Product Change Notification / LIAL-25 APCS160

CCB 4779 Final Notice: Qualification of C194 lead frame with Ag on lead only die attach paddle (DAP) surface prep material for TC130xA, TC130xB, MCP6x2, MCP1612 and MCP1726 device families available in 8L DFN (3x3x0.9mm) package at NSEB assembly site.

CCB 4779
Pre and Post Change Summary
PCN#: LIAL-25APCS160

Pre Change

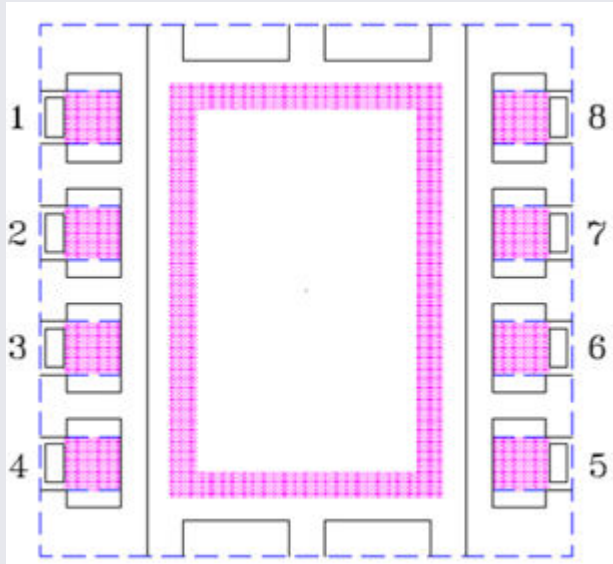
Lead frame material	EFTEC-64T
Lead frame DAP surface prep	Ag ring

Post change

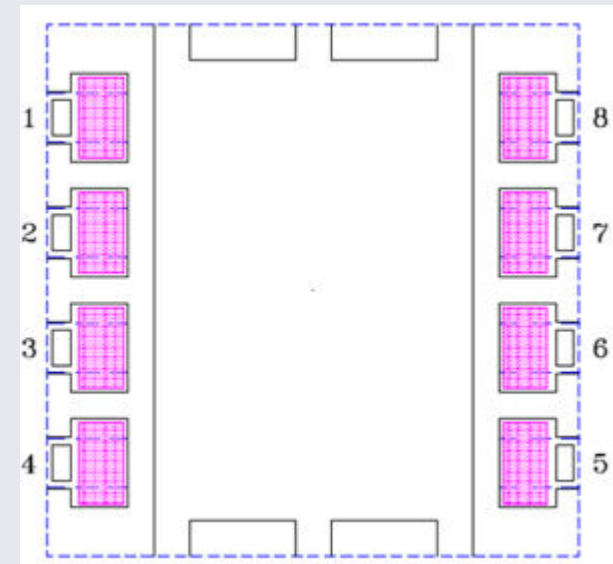
Lead frame material	C194
Lead frame DAP surface prep	Ag on lead only
